# **Planning Rationale + Design Brief**

**3075 PALLADIUM DR., OTTAWA**

Site Plan Control Application

**Prepared by: TAES Architects Inc**

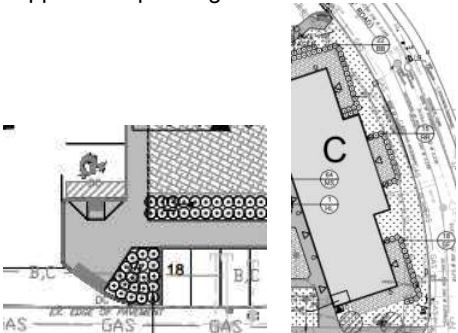
72	<p>The projected canopy cover for the site is 11%. It appears that there is space to plant additional trees east of building C, to improve both the canopy cover and streetscape in this area. In other areas, consider expanding some of the parking lot islands/boulevards or reducing the sidewalk coverage or # of parking spaces to support tree planting.</p> 	Addressed. Please refer to updated Landscape Plan.
73	As per the direction of the Official Plan, Section 4.8.2 Policy 3, it is strongly recommended to provide additional space within the site to plant trees to increase the canopy cover projection and to decrease the urban heat island effect from the large amount of parking.	Additional trees are provided. Please refer to updated Landscape Plan.
74	Please consider replacing proposed vegetation with invasive tendencies (e.g. Euonymus alatus) with native or non-invasive species.	Addressed. Please refer to updated Landscape Plan.

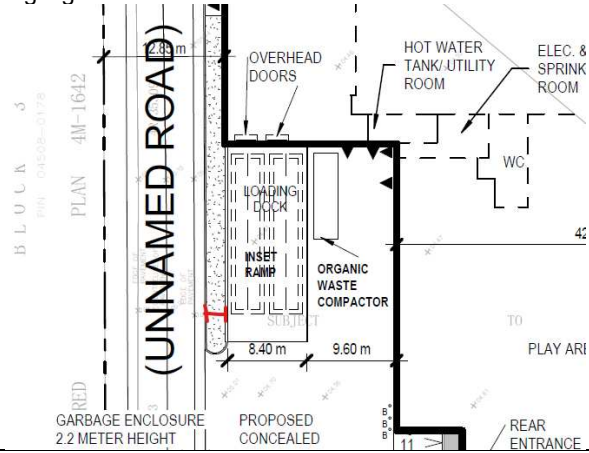
78	Accessible spaces required from 251-300 spaces is 8. 4 type A spaces and 4 type B spaces. Only 3 type B spaces where provided, please revise site plan to add 1 addition Type B parking space.	TAES: Per table 11 By Law 2008-250, 237 parking space on the site require 3 Type A spaces and 4 Type B Spaces. The site plan has been updated to include the necessary accessible spaces accordingly.
79	Refuse collection is located in the rear yards, please provide a detail of how it will be screened in. Outdoor refuse collection as per section 110(3) must have an opaque screen of minimum 2m in height.	TAES: A drawing of plan and elevations for garbage enclosure has been added to the site plan. According to the design, the opaque screens are 2.2 meters high.
80	Bicycle parking for retail food store and retail store is 1 per 250m <sup>2</sup> of GFA. With the GFA of all buildings being 7770.94m <sup>2</sup> the required amount of bicycle parking spaces is 31, at the moment only 26 spaces are showing, please revise, also please show the dimension of the spaces. Horizontal spaces must be 0.6m x 1.8m.	TAES: Per table 111 By Law 2008-250, 28 parking spaces are required and the site plan provide 28 proposed spaces accordingly. The Typical dimensions of bicycle spaces have been marked on site plan.

81	Loading spaces are required for the retail food store, because of the gross floor area 2 loading spaces are required, please identify those loading spaces and make	TAES: 2 Loading space has been provided on site plan.
